SUBJECT: Seneca Army Depot Activity, Response to Comments on Draft Final Decision Document for the Inhibited Red-Fuming Nitric Acid (IRFNA) Disposal Sites (SEAD-13)

Subject: Draft Final Decision Document for SEAD-13
Seneca Army Depot
Romulus, New York

Subject: Draft Final Decision Document – Mini Risk Assessment for the Inhibited Red Fuming Nitric Acid (IRFNA) Disposal Site (SEAD-13)
Seneca Army Depot
Romulus, New York

FIGURE 2-6
 SEAD-13 IRFNA Disposal Site
 Groundwater Elevation Plan
 April 2002

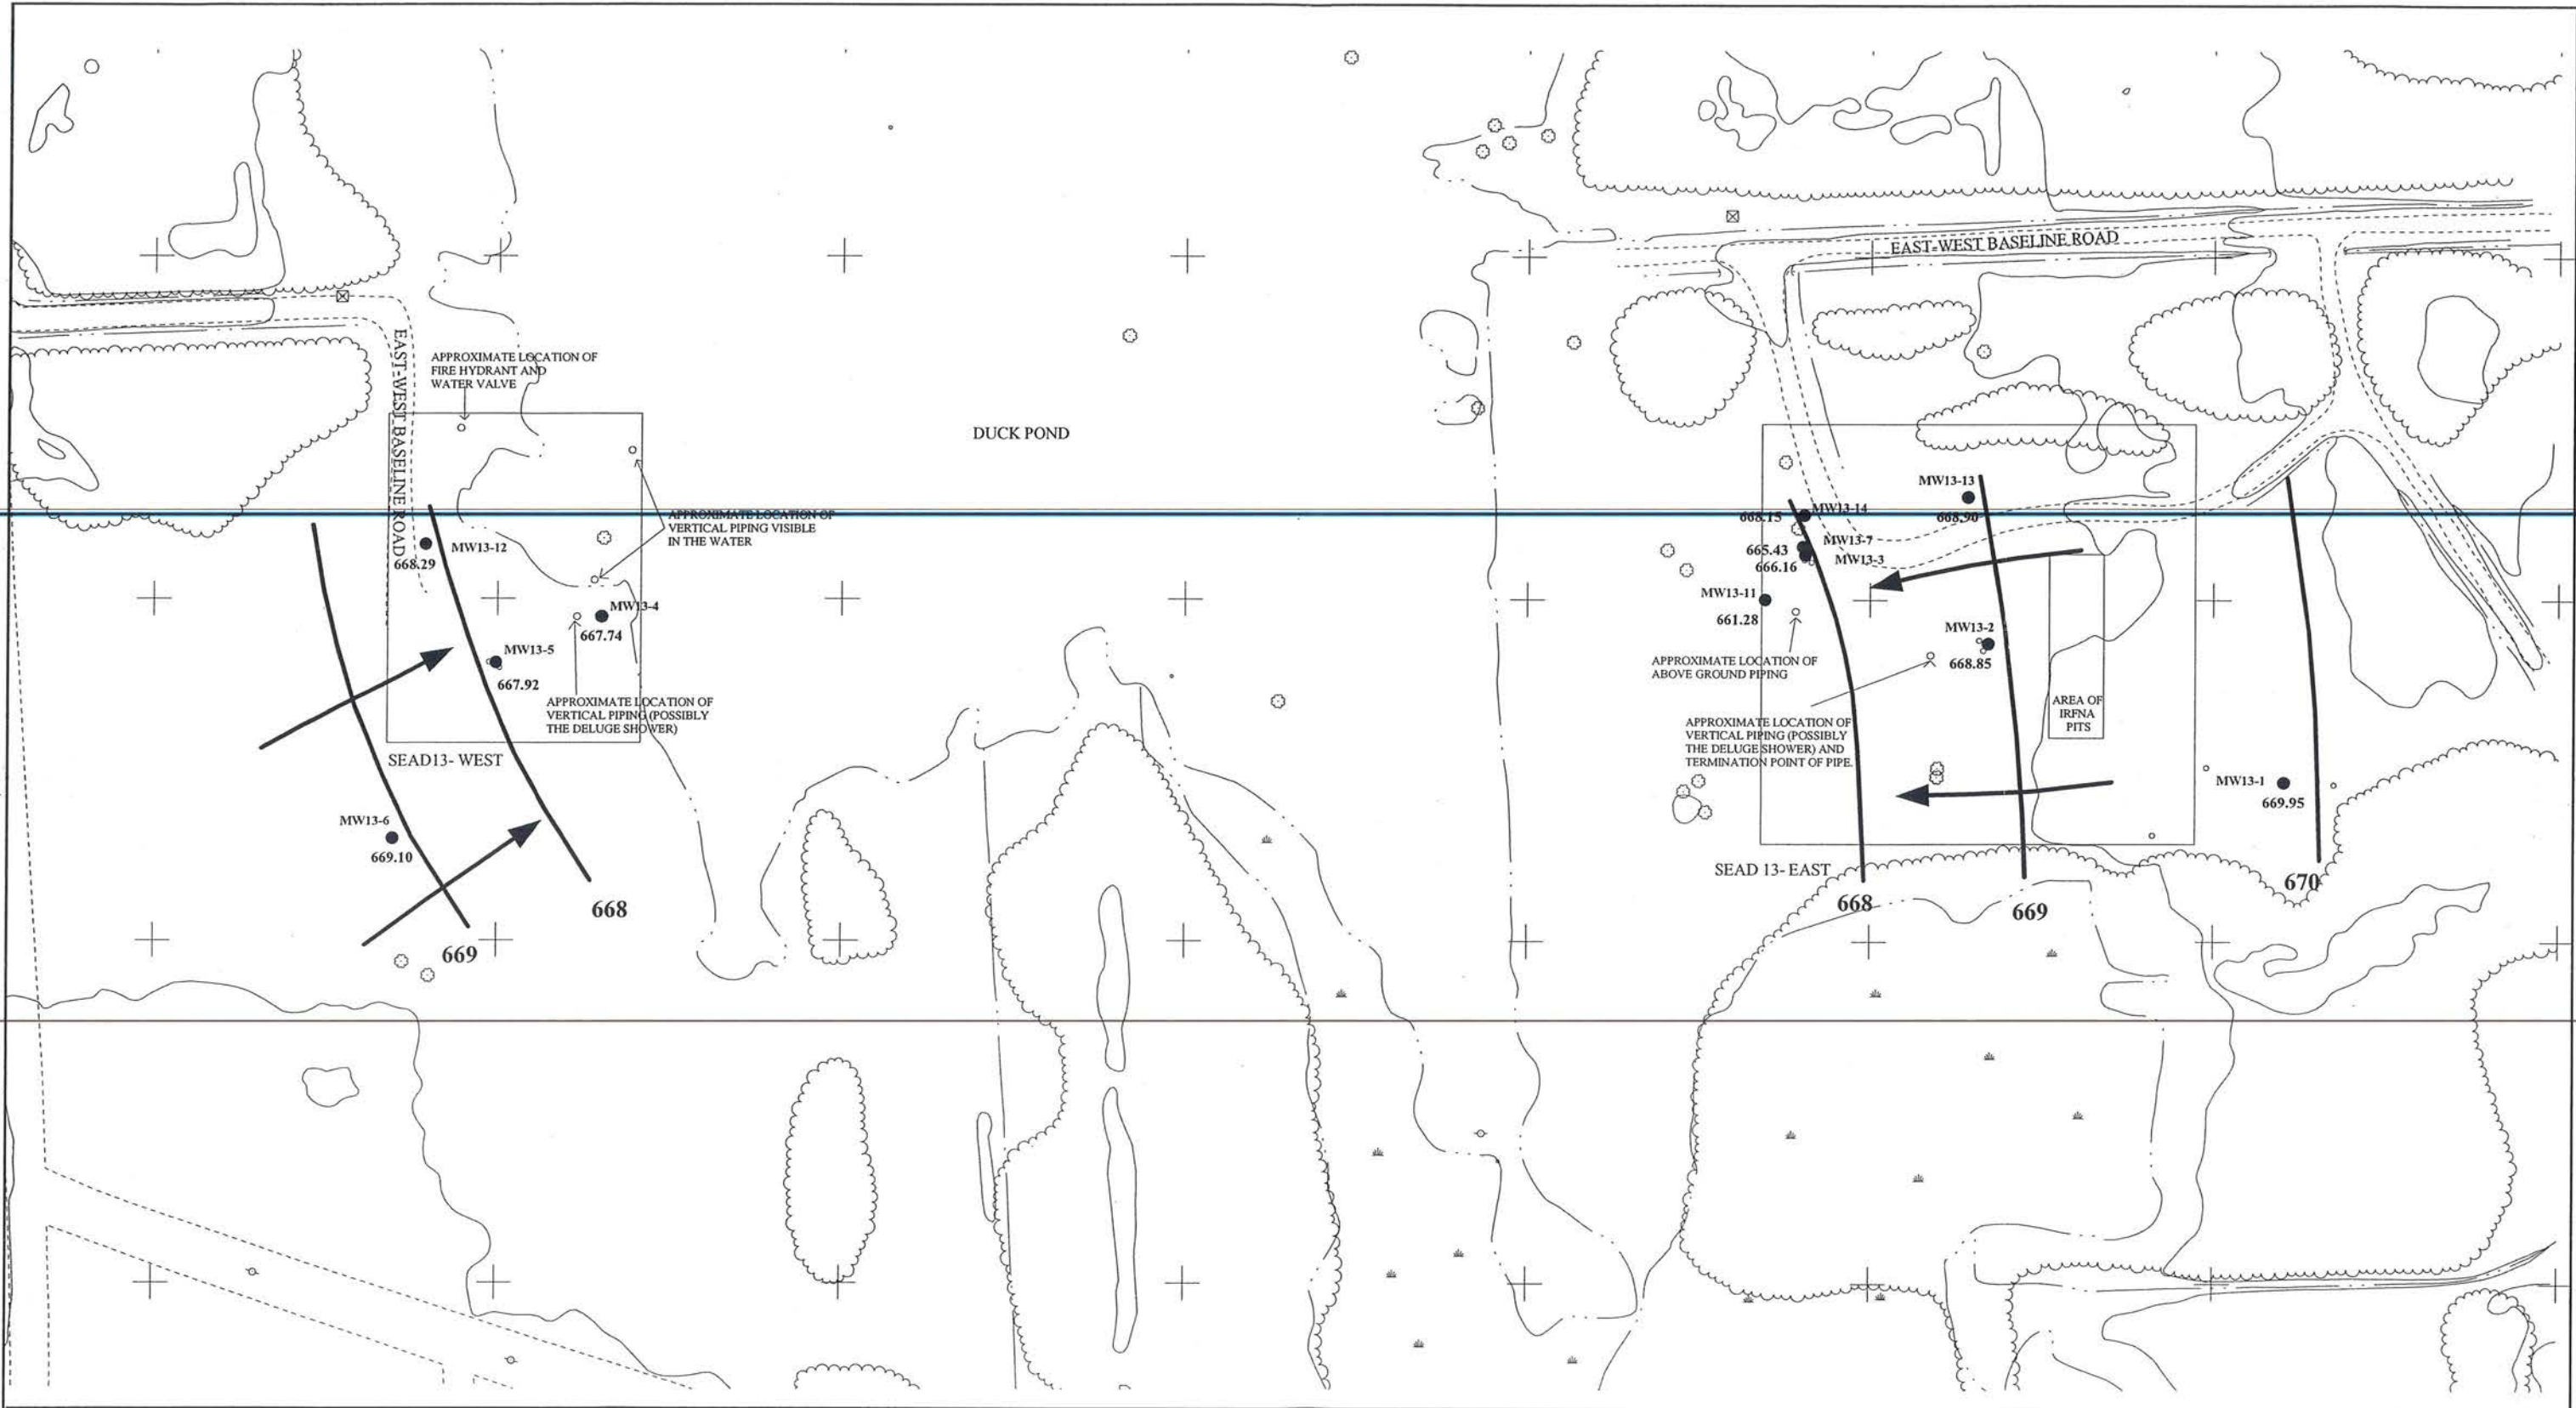
flow is in conflict with the upgradient and downgradient designations for the wells. Revise accordingly.

Comment 8: Although discussed in the text, there should be a figure denoting the direction of groundwater flow.

Comment 14: Figures 2-1 through 2-7: On these figures it is unclear where the suspected IRFNA pits are on the west side of the site. Therefore it is difficult to support the Army’s location of monitoring wells and sampling points on the west portion of the site. Also, groundwater direction should be indicated where appropriate.

The presumed groundwater flow is now discussed in new Section 2.5.4 and shown on Figure 2-6.

Response 8: Agreed. The direction of groundwater flow has been added to Figure 2-6.

The direction of groundwater flow has been added to a new Figure 2-6. In general, groundwater flows toward the Duck Pond. It should be noted that Figures 2-6 and 2-7 have been renumbered as figures 2-7 and 2-8, respectively.
